SHINE MEDICAL TECHNOLOGIES, INC.

**SHINE MEDICAL TECHNOLOGIES, INC. APPLICATION FOR CONSTRUCTION PERMIT
PRELIMINARY SAFETY ANALYSIS REPORT REVISIONS**

REVISION 1 OF THE SHINE RESPONSE TO RAI 12.1-1 AND RAI 12.2-1

**PRELIMINARY SAFETY ANALYSIS REPORT CHANGES
(MARK-UP)**

Figure 12.1-1 – SHINE Operational Organization Chart

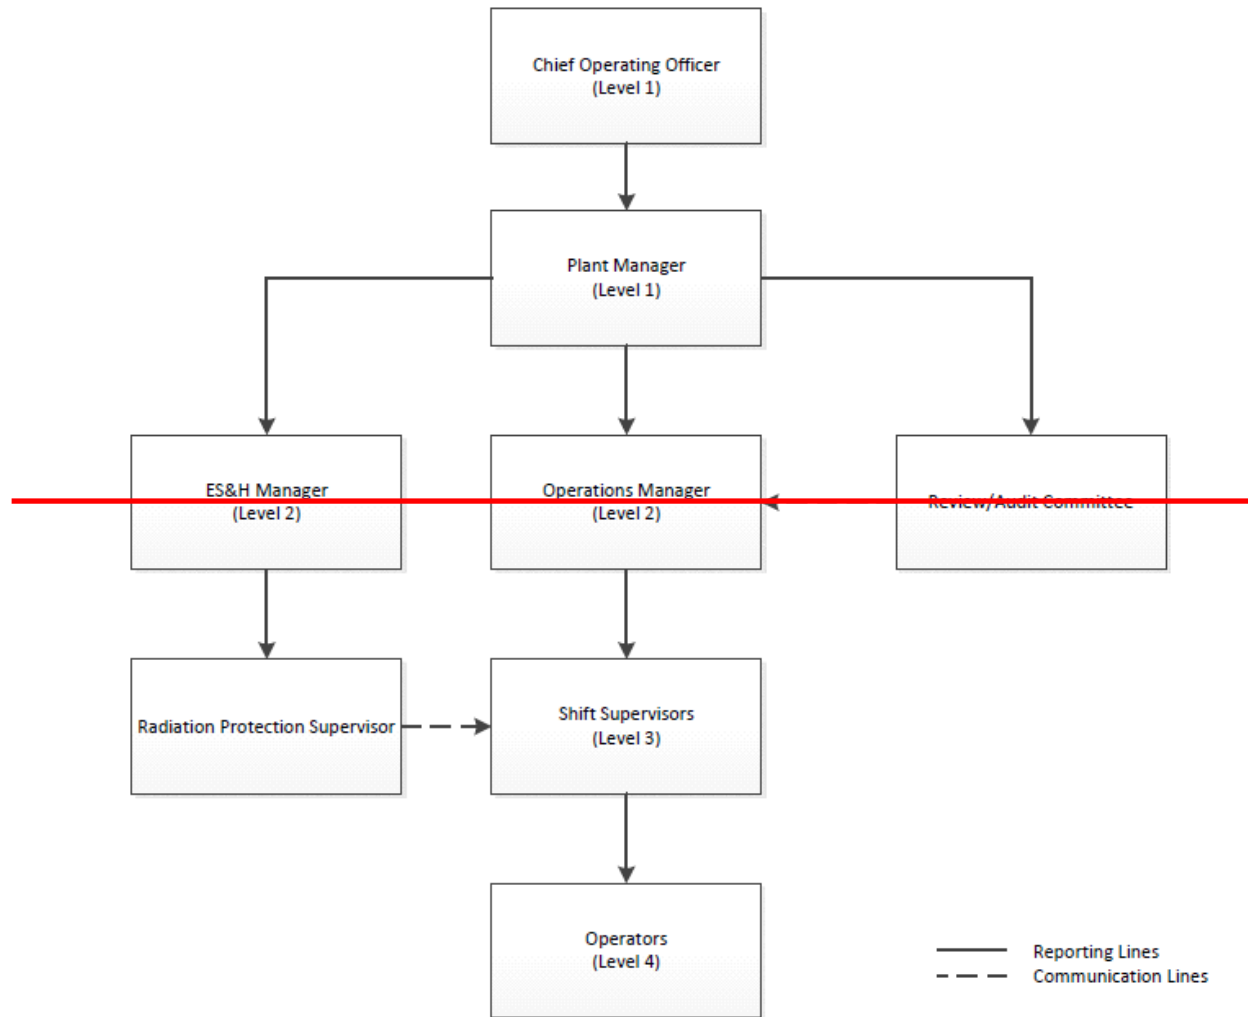
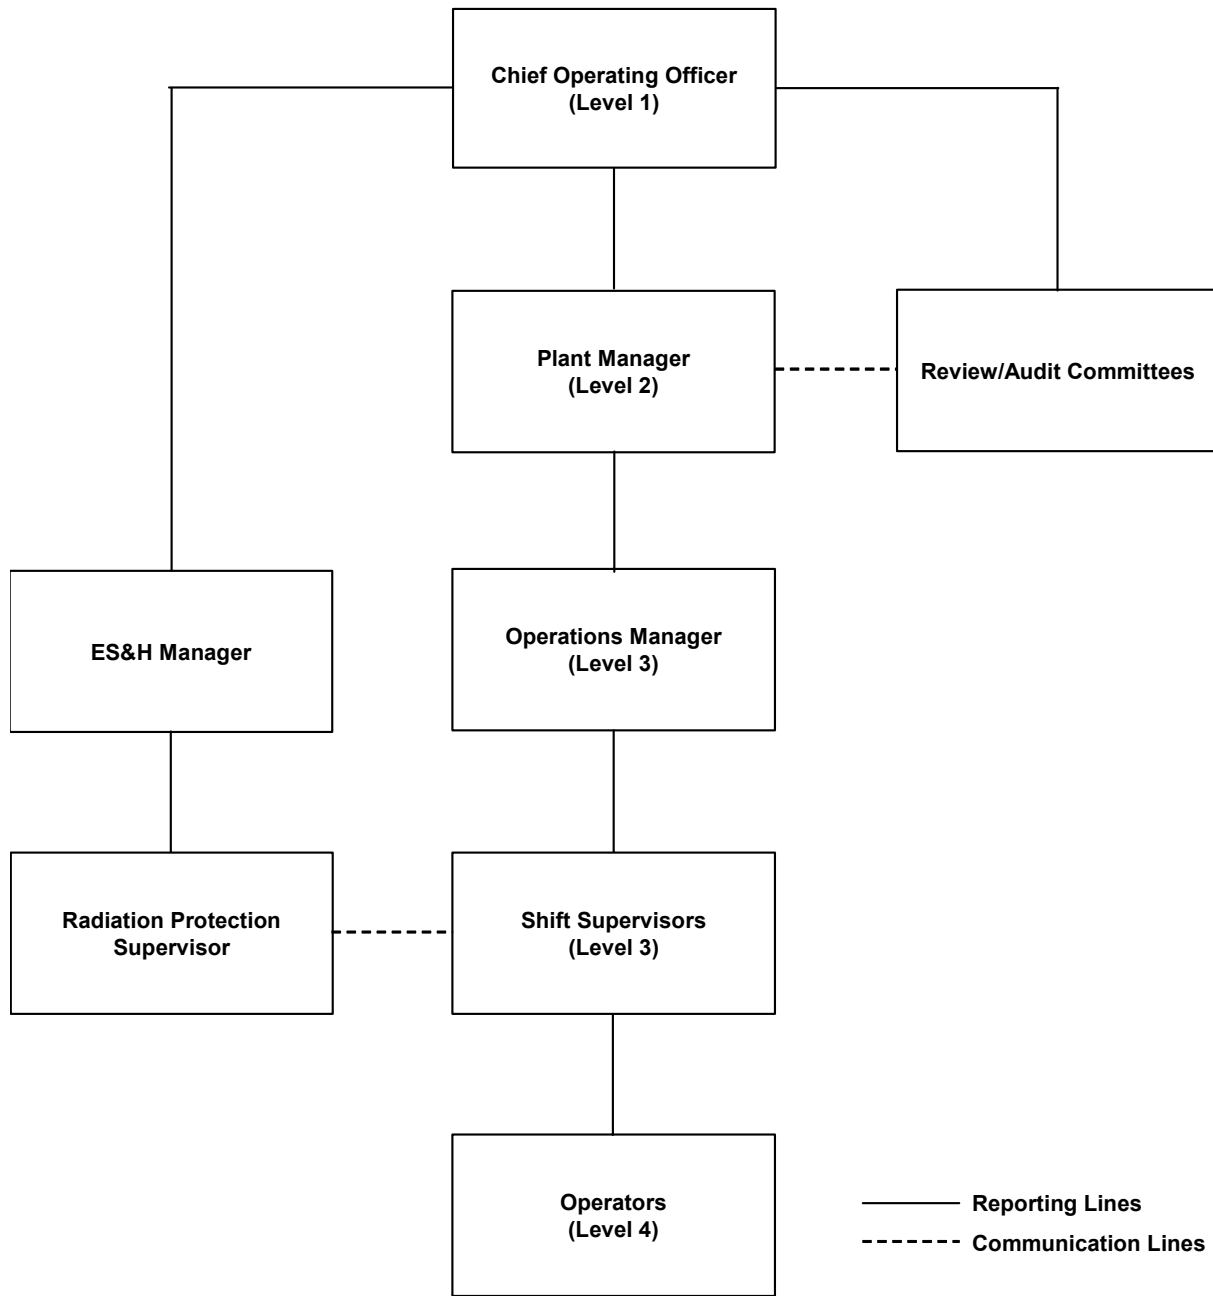
Plant Operators (Level 4) report directly to the Shift Supervisors (Level 3). The RP Supervisor reports directly to the Environment, Safety, and Health (ES&H) Manager (~~Level 2~~) and has communication lines with the Shift Supervisors. The Shift Supervisors report directly to the Operations Manager (Level ~~2~~3). The Operations Manager reports to the Plant Manager (Level 2). The ES&H Manager reports to the Chief Operating Officer (Level 1). The Review/Audit Committees reports to the ~~Plant Manager (Level 1)~~Chief Operating Officer and ~~has have~~ communication lines with the ~~Operations Plant~~ Manager. ~~The ES&H Manager and Operations Manager report to the Plant Manager.~~ The Plant Manager reports to the Chief Operating Officer (~~Level 1~~).
